Post Exhibition - Planning Proposal - 47-51 Riley Street, Woolloomooloo - Sydney Local Environmental Plan 2012 and Sydney Development Control Plan 2012 Amendment

File No: X087762

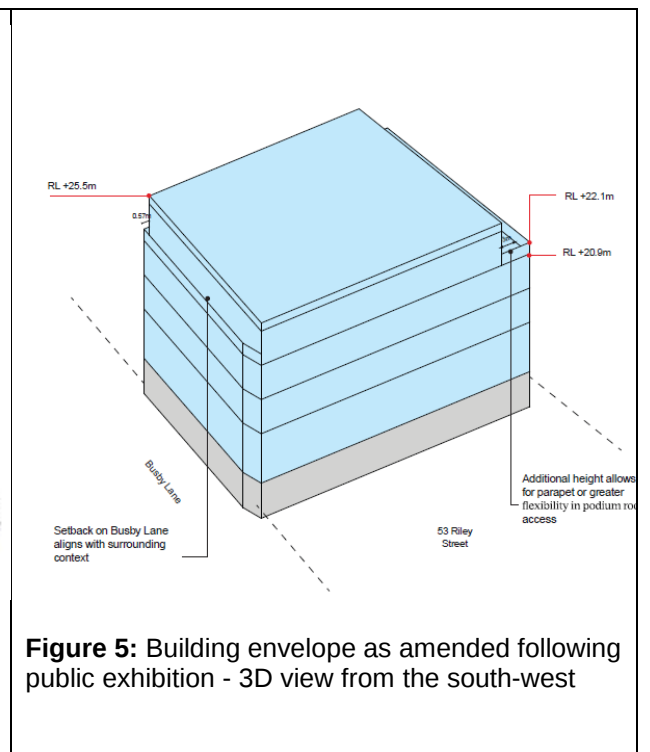
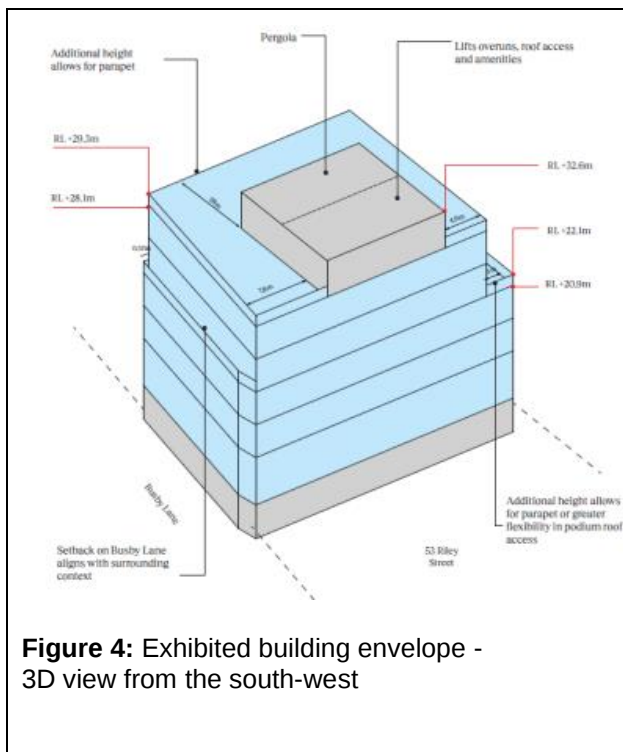
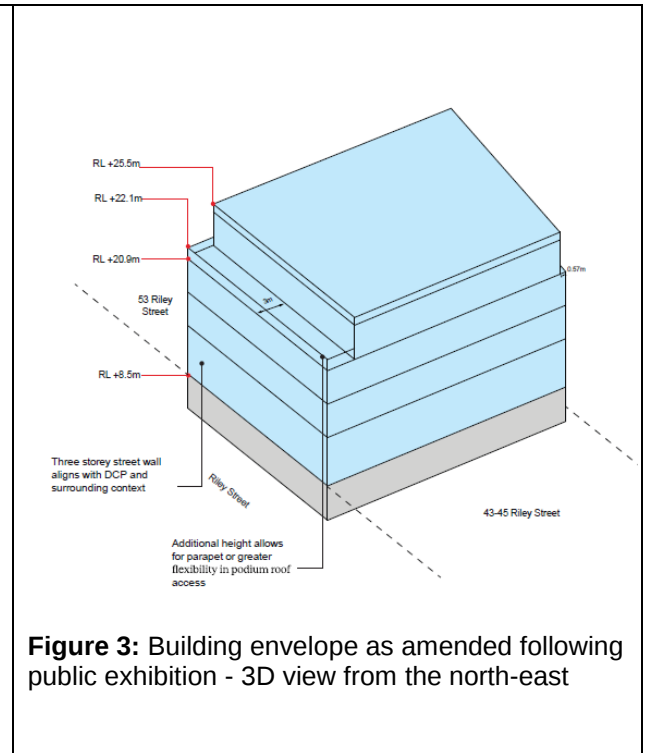
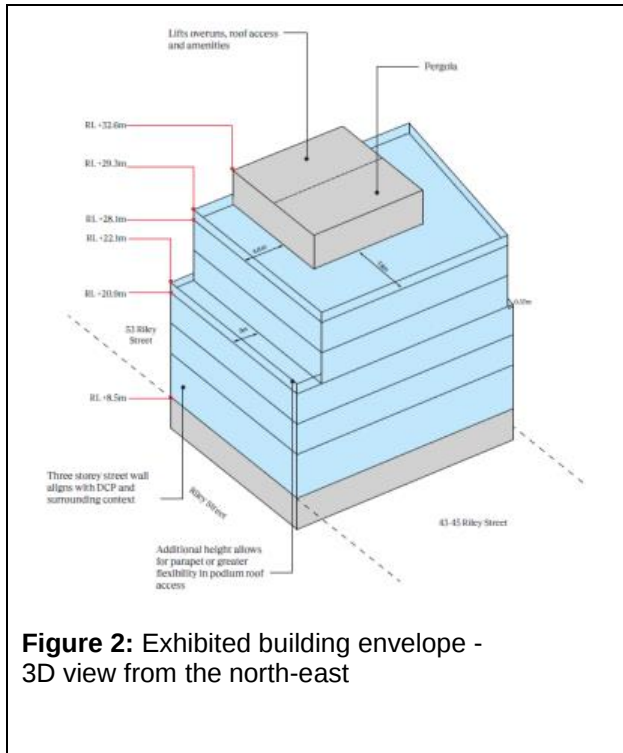
29. There were 106 submissions which referred to the height, bulk and scale of a future building.
30. Of these, 100 submissions raised objection on the basis that the proposal would facilitate a building of excessive height, bulk and scale. Many submissions noted that the proposed 25m height control would be more than doubling the existing 12m height control, and that the proposed building envelope would result in an overbearing, bulky and out-of-scale building.

- the proposed maximum building height be reduced by 7.1m to RL 25.5m from the exhibited maximum height of RL32.6m and
 - the proposed maximum FSR be reduced from 3.8:1 to 3.2:1, to match the height reduction.

38. Figures 2, 3, 4 and 5 provide a comparison of the exhibited planning proposal's building envelope with the building envelope as amended following public exhibition.

Figure 6: Riley Street elevation in context of surrounding development - exhibited draft planning controls

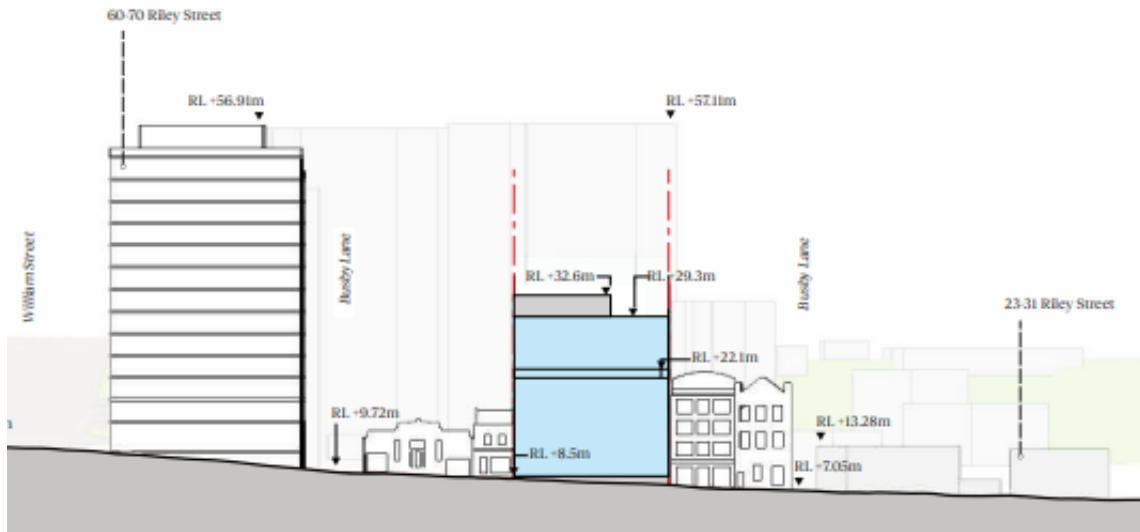
40. Submissions stated that the proposal would enable the construction of a large, overbearing development that would dominate the western side of Riley Street and be contrary to the low-rise character of development within the subject street block and Woolloomooloo more generally. There was concern that the increase in height and the abrupt change in scale is not visually consistent with surrounding structures, and that the proposal would create an uncomfortable transition with the 2-storey terrace to the immediate south at 53 Riley Street. Submissions stated that the exposure of a significant portion of blank wall on the southern elevation would adversely impact on the Riley Street streetscape and public domain views, and that this would be likely to remain exposed in perpetuity given the heritage item at 55-61 Riley Street (Lessey's Garage) and the contributory building at 53 Riley Street.

43. Figures 6 and 7 show images of the Riley Street elevation of a future development on the site in the context of surrounding development. The exhibited planning controls are at Figure 6, and the recommended amendments to these planning controls following public exhibition is at Figure 7.

41. It is recommended that the maximum height control and maximum FSR control for the site be reduced as set out in paragraph 34 above. It is also recommended that restrictions be imposed so that there are no roof-top structures above the maximum height control. These recommendations would have the effect of reducing the overall height, bulk and scale of a future building on the site, thereby reducing visual impacts on the streetscape and the public domain.

42. With a maximum building height of RL25.5m, a future building on the site would be the tallest within the street block, but not significantly taller than the neighbouring building at 43 Riley Street or the heritage item (Brandt Bros Ltd) at 41 Riley Street. A future building will still have a height and scale difference with the neighbouring buildings at 53 Riley Street and 55-61 Riley Street, but this will be less than what was proposed with the exhibited proposal. There would still be a side blank wall on the southern elevation of the building, but the extent of blank wall would be reduced as a result of the height and FSR control reductions. The height and scale relationships with the adjoining buildings is considered reasonable in this urban context.

Figure 7: Riley Street elevation in context of surrounding development - recommended amendments to draft planning controls following public exhibition

Figure 8: View of building envelope as amended following public exhibition, looking south up Riley Street towards William Street

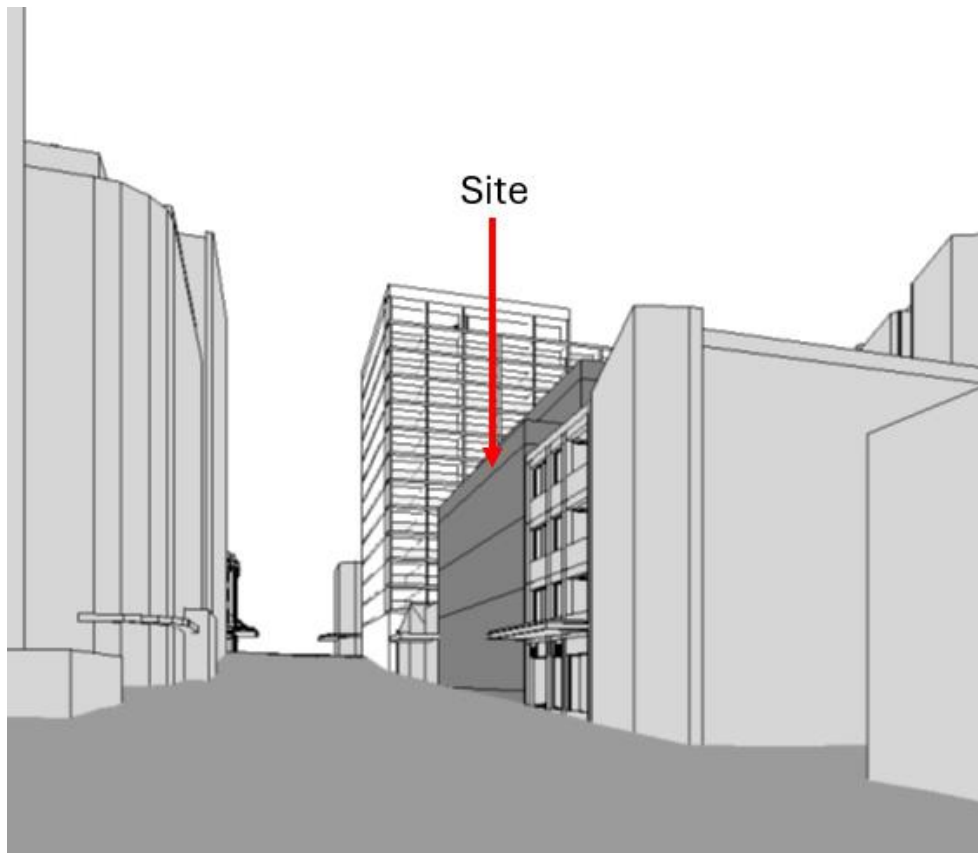
39. There were 93 submissions which referred to the proposal's impact on the area's character, the streetscape and public domain views. Of these, 84 submissions raised objection to how the proposal would impact on Woolloomooloo's character, the Riley Street streetscape and views available from the public domain, including vantage points on nearby William Street.

44. Figures 8 and 9 show the building envelope with the recommended changes to the draft planning controls in the context of the public domain.

45. It is considered that detailed design could achieve a commercial building that respects neighbouring buildings and the character of the Woolloomooloo Heritage Conservation area, while not resulting in unreasonable impacts upon nearby contributory buildings or heritage items.
46. The DA stage of the development will provide an opportunity for the detailed design of a building which is acceptable in terms of visual impact and responds appropriately to the streetscape and public domain.

Figure 10: Indicative view impact analysis with planning controls as amended following public exhibition. Impact on view at Level 4 (Unit 16) of Paramount Apartments at 60-70 William Street, Woolloomooloo.

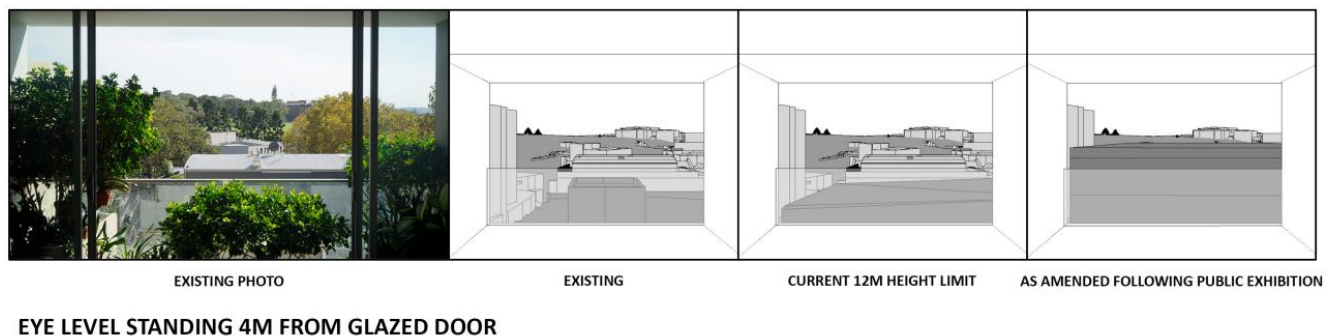
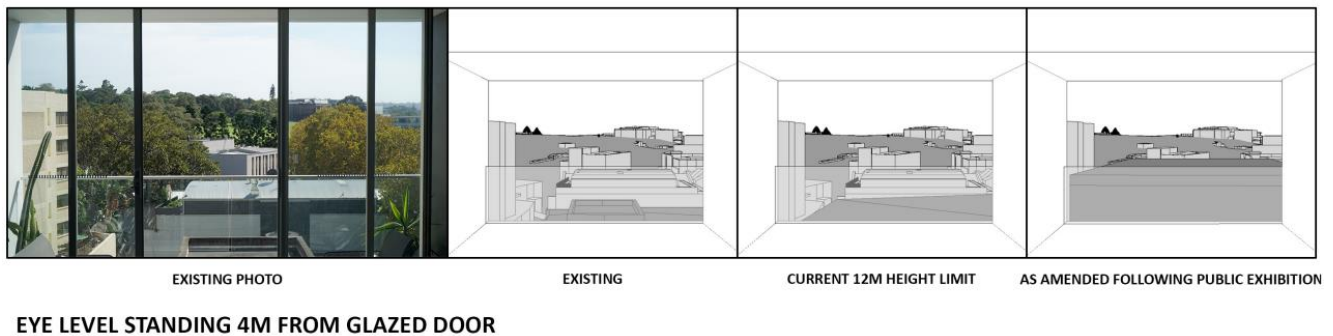
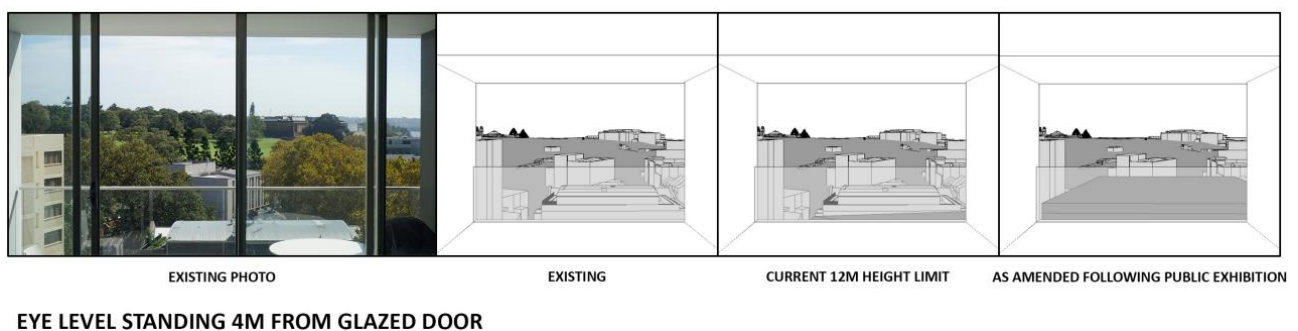
58. There were 84 submissions which raised concerns about the impact of the proposal on the views and outlook enjoyed by neighbouring residential properties. Of these, 82 raised objection to the proposal on the basis that it would significantly impact the views and outlook from private residential properties, reducing the amenity, liveability and enjoyment of homes and having a detrimental impact on property values.

59. The most objection regarding view loss and impact on outlook has come from owners and residents of apartments within the Paramount Apartment complex at 60-70 William Street, Woolloomooloo. The City's view impact assessment has considered the impacts on the views and outlook available from apartments in this building on the basis that the impact is greatest on this building.

70. These proposed amendments to the planning proposal would reduce the impact on the views of neighbours. City staff have undertaken an independent view impact analysis to assess the impact of a future building within these reduced controls – see Attachment G. Extracts from this view impact analysis are set out in Figures 10, 11 and 12. An assessment of the extent of the impact with the reduced controls indicates:

- Apartments on the sixth floor have desirable land views and water views and the proposal would have a negligible impact on these views from the living areas.

- Apartments at level seven have desirable land views and water views and these will largely be retained.
 - For the apartments on level eight and above, the proposal will not result in any view loss.

71. Even with the proposed reduced controls, some view loss and impact on outlook will occur to some apartments within the Paramount Apartment complex and other nearby residential buildings. Being located in an urban context and within the City Fringe, it is inevitable that new development will affect the views and outlook of residential developments to some extent. It is considered that with the reduced controls and restrictions on roof top development, the impact on views enjoyed by neighbouring properties will be reduced and the opportunity for view sharing increased, such that the impact on views is reasonable in the context.
